Rosamond High Early College Campus Cafeteria Building
SOUTHERN KERN UNIFIED SCHOOL DISTRICT
F&M Project No. 2990
Bid Clarification No.3; Page 1 of 2

BID CLARIFICATION NO. 4

July 18, 2023

Sheet No. **A2.03**

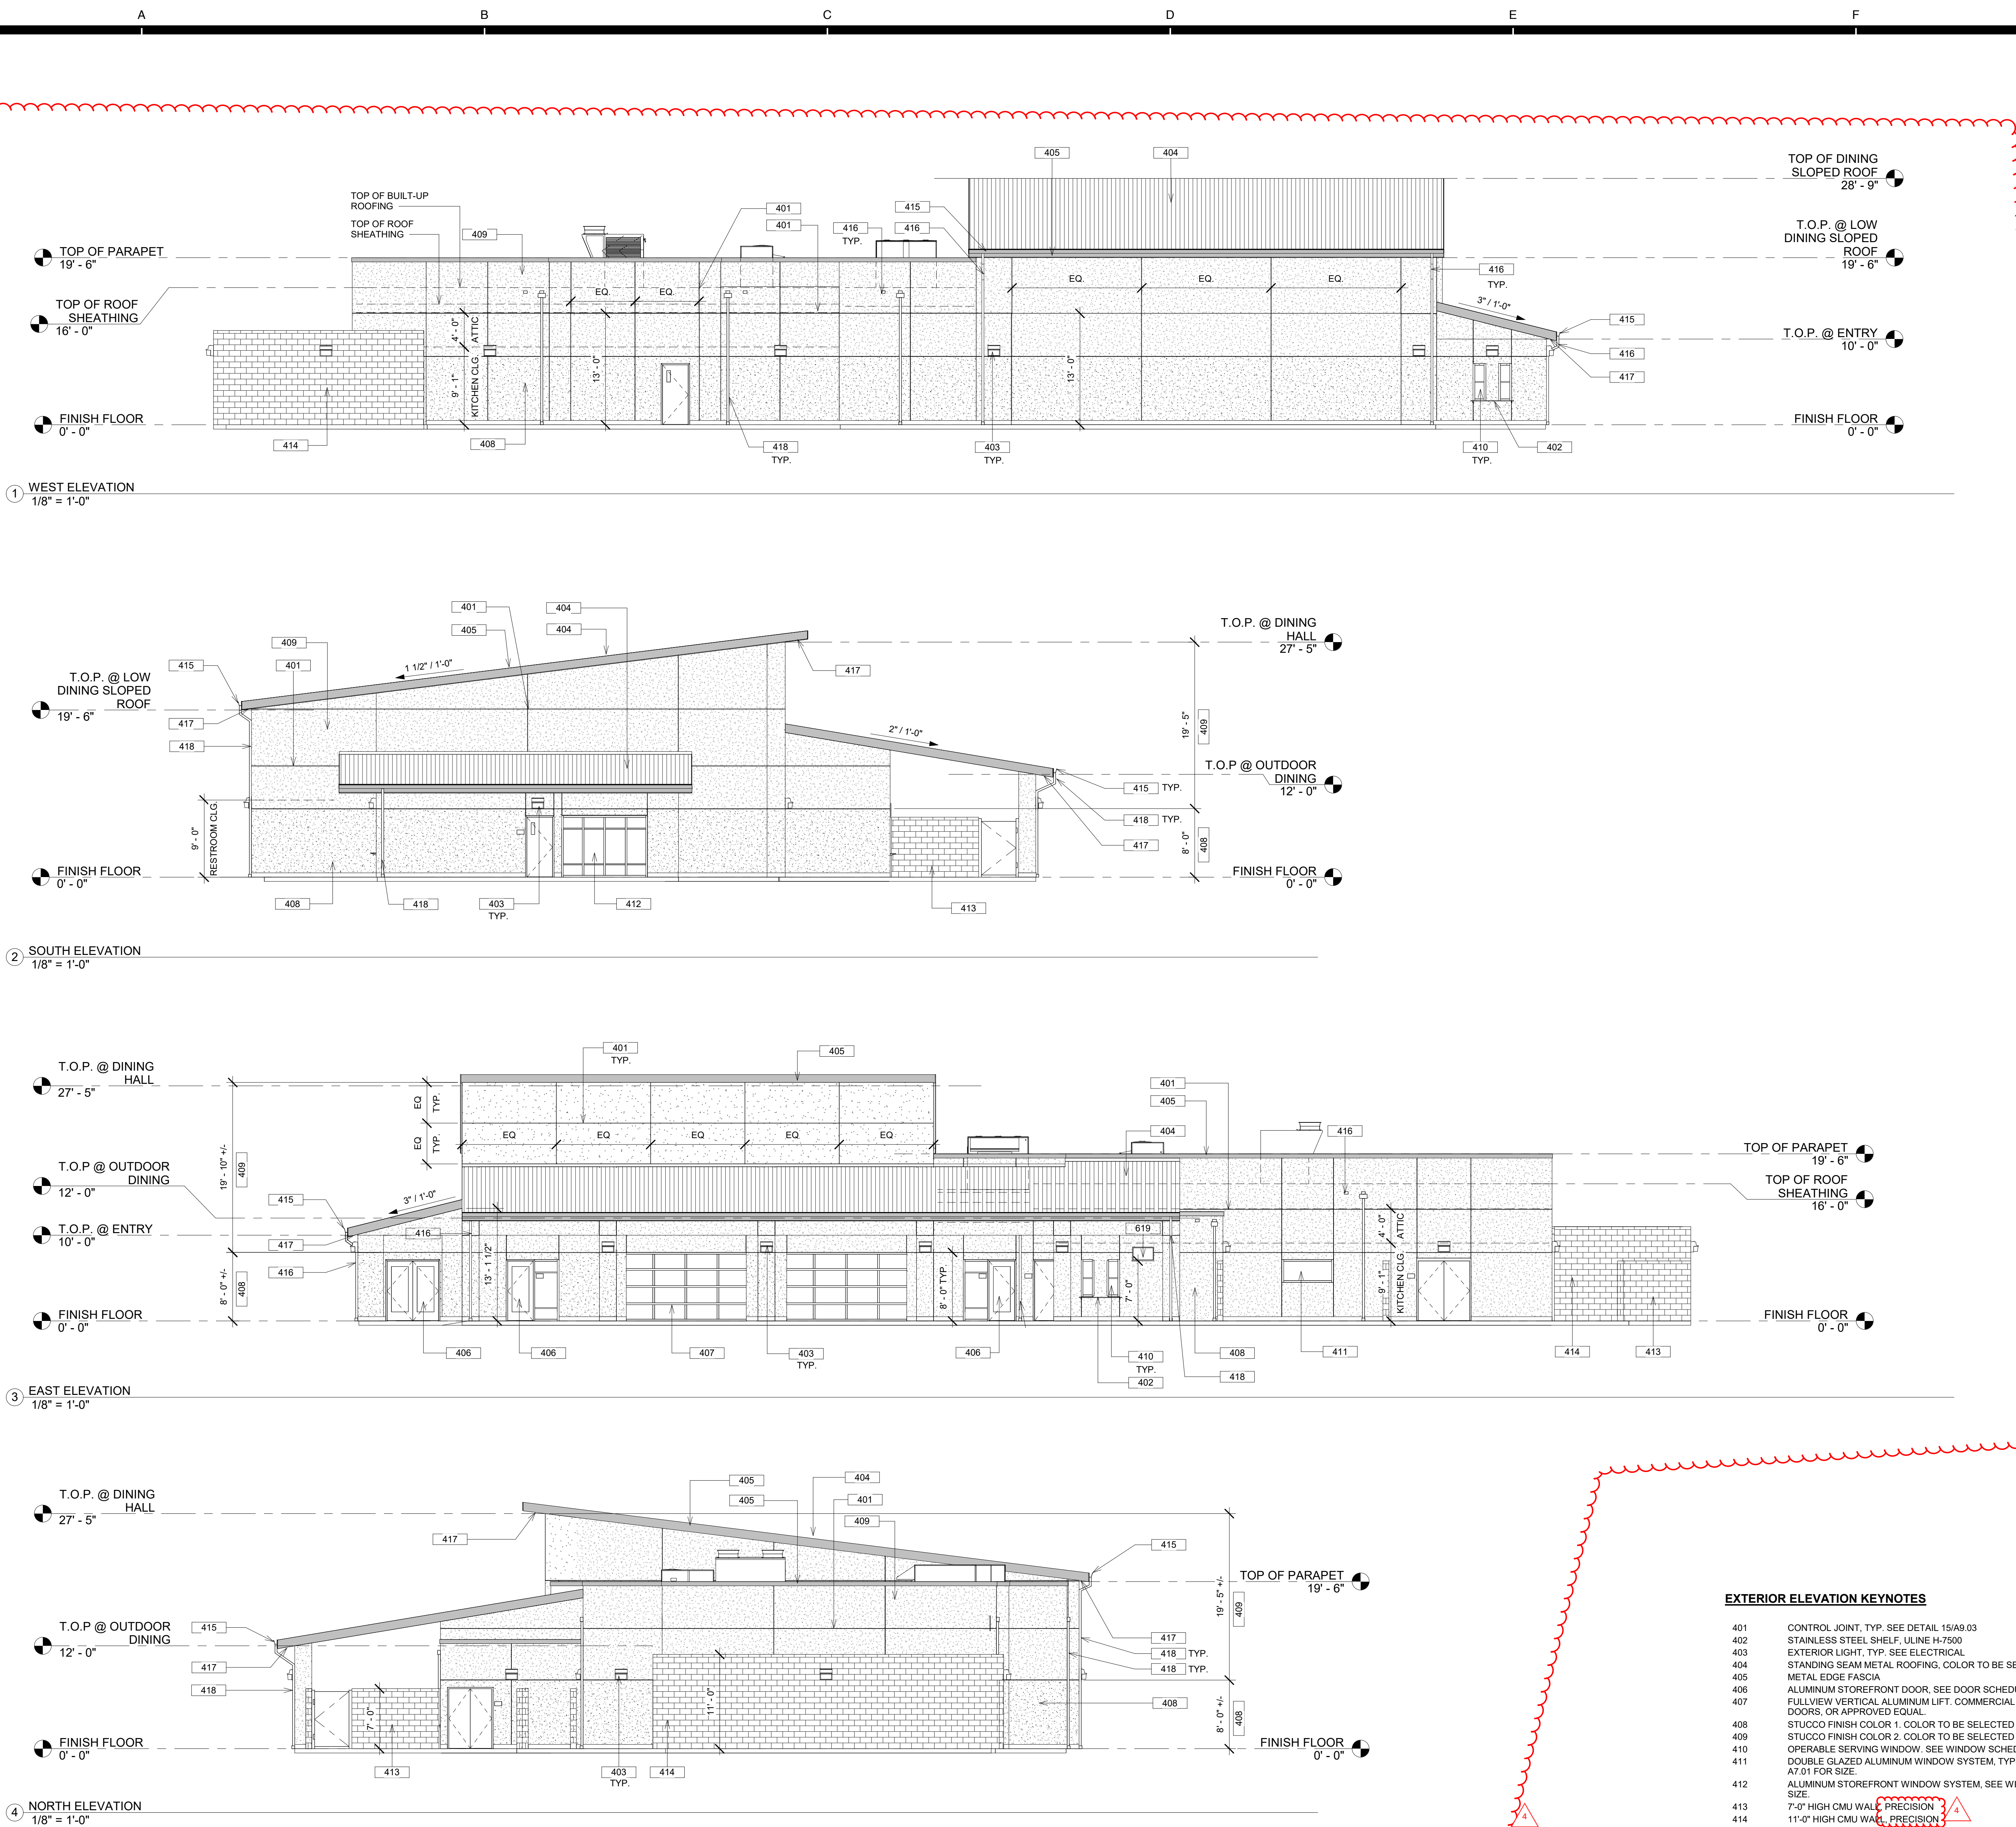
5. A2.02 – Reflected Ceiling Plan, "Bid Clarification No. 4", with revision clouds as attached hereto.
6. A2.03 – Roof Plan, "Bid Clarification No. 4", with revision clouds as attached hereto.

BUILDING SECTIONS

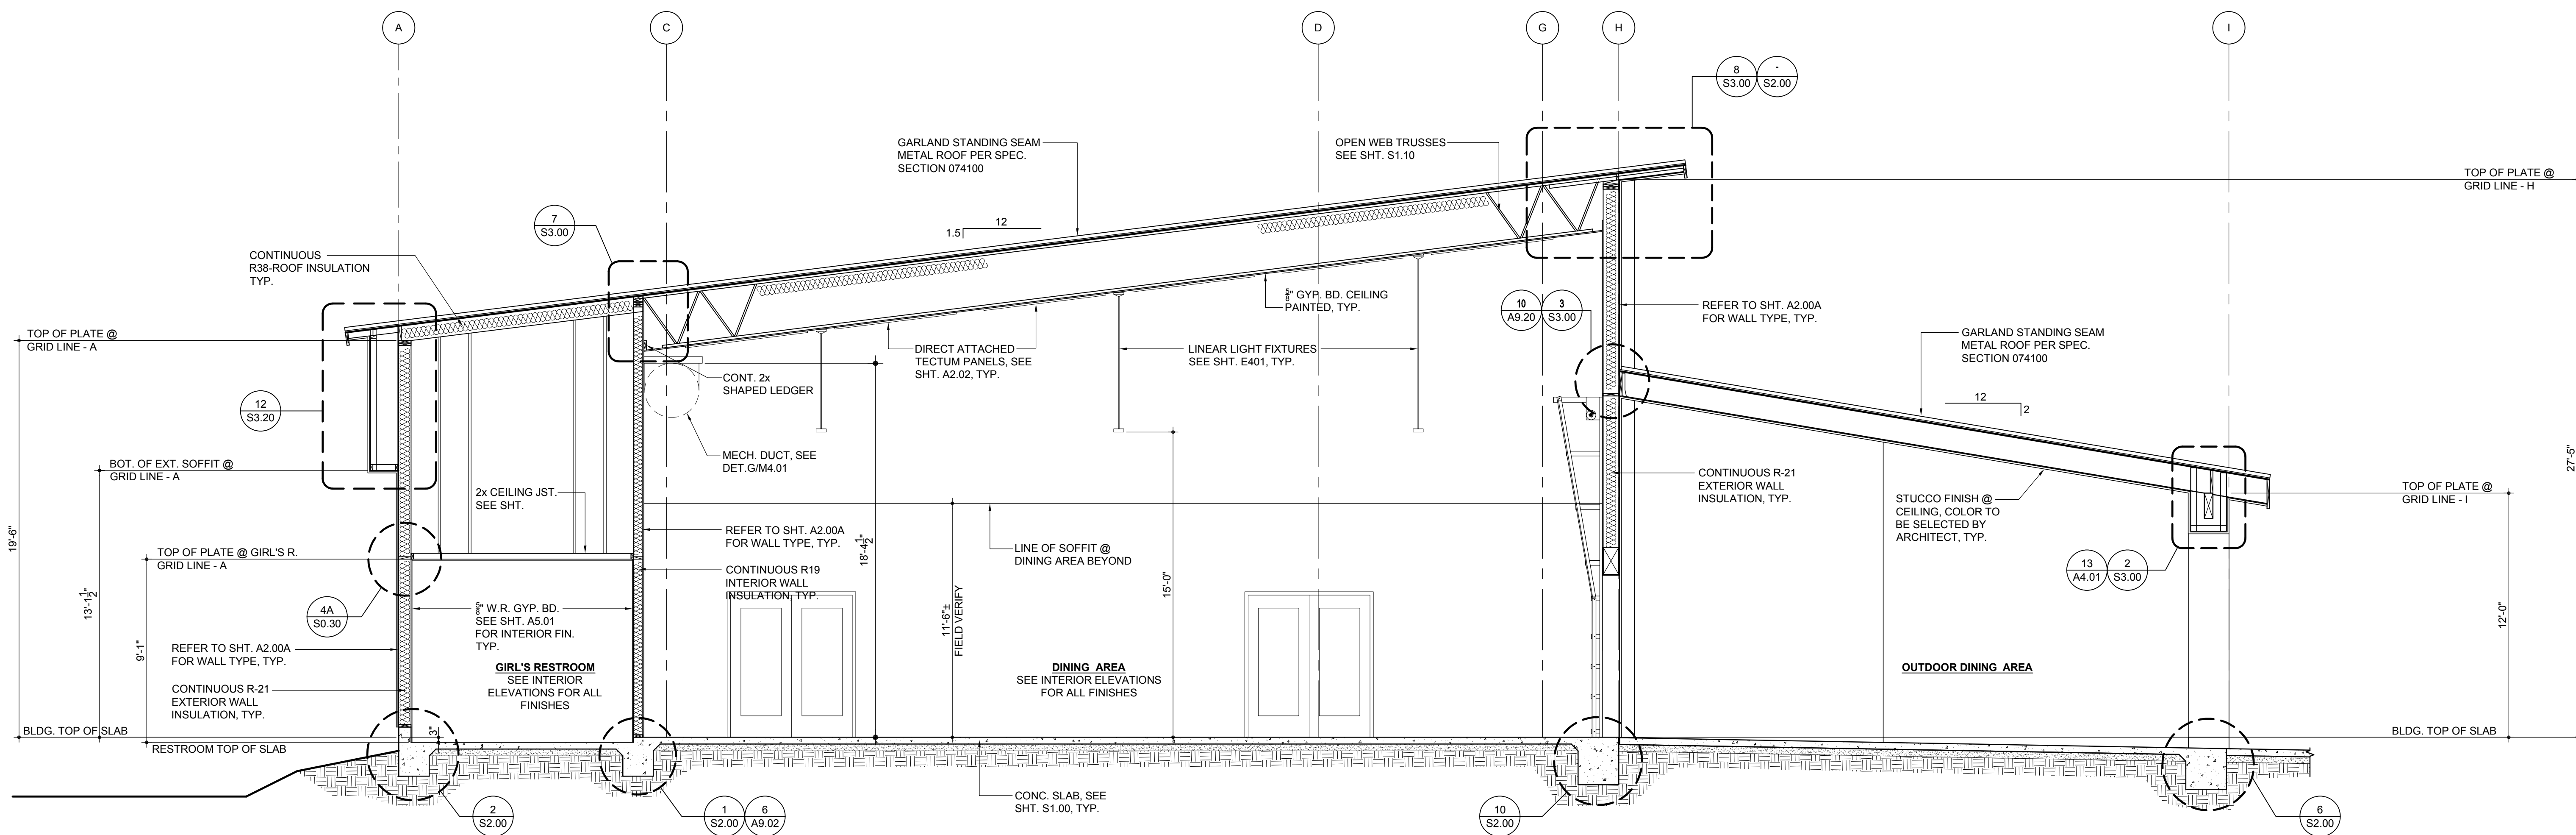
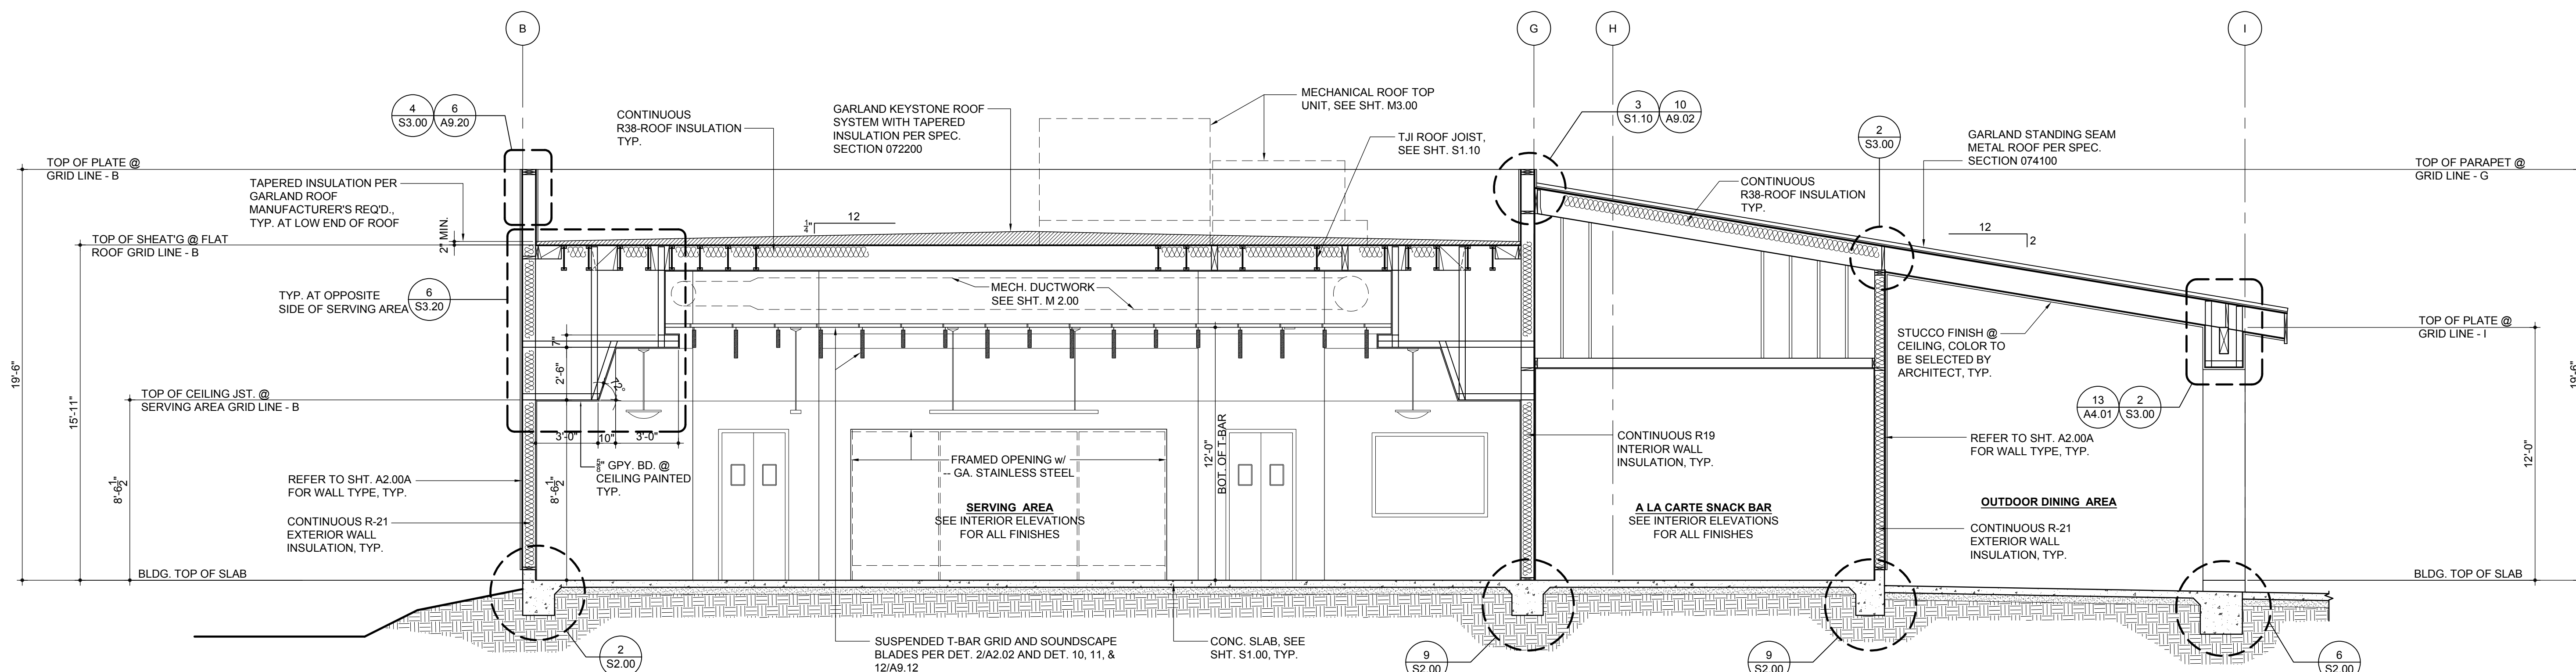
7. A3.01 – Exterior Elevations, "Bid Clarification No. 4", with revision clouds as attached hereto.
8. A4.01 – Building Sections, "Bid Clarification No. 4", with revision clouds as attached hereto.

SCHEDULES

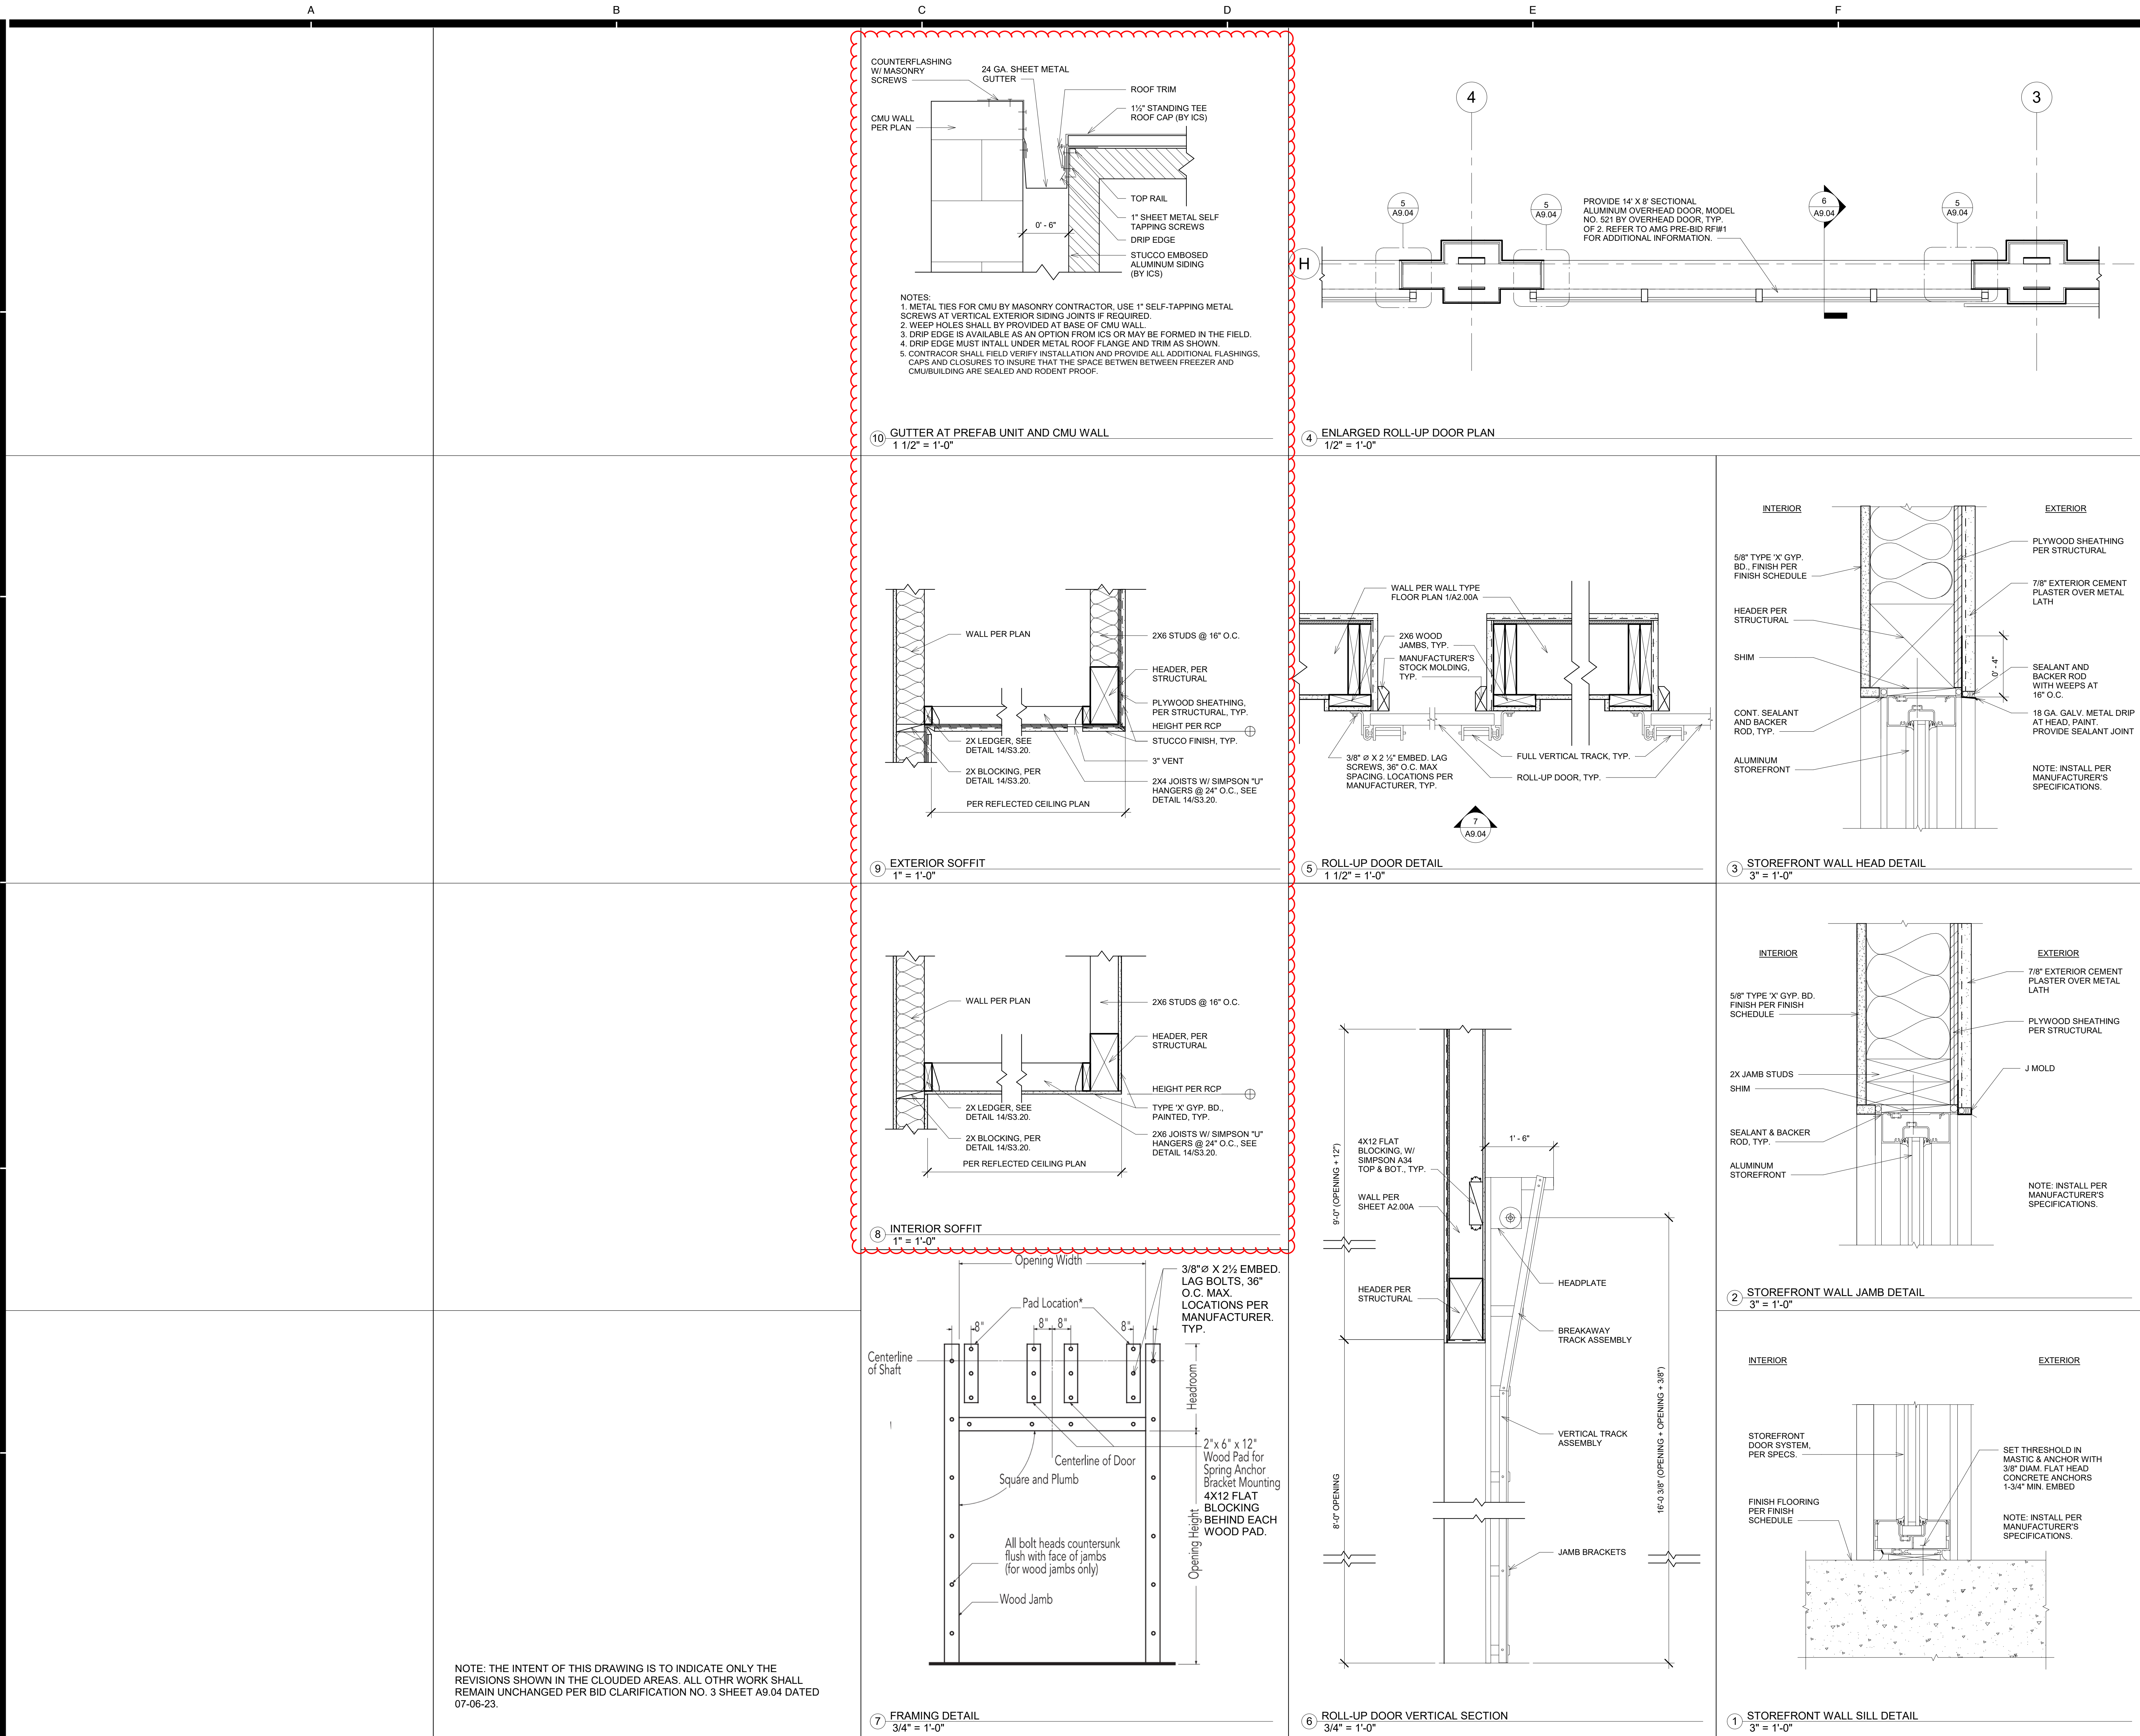
12. A7.01 – Schedules, “Bid Clarification No. 4”, with revision clouds as attached hereto.
13. A9.04 – Details, “Bid Clarification No. 4”, with revision clouds as attached hereto.
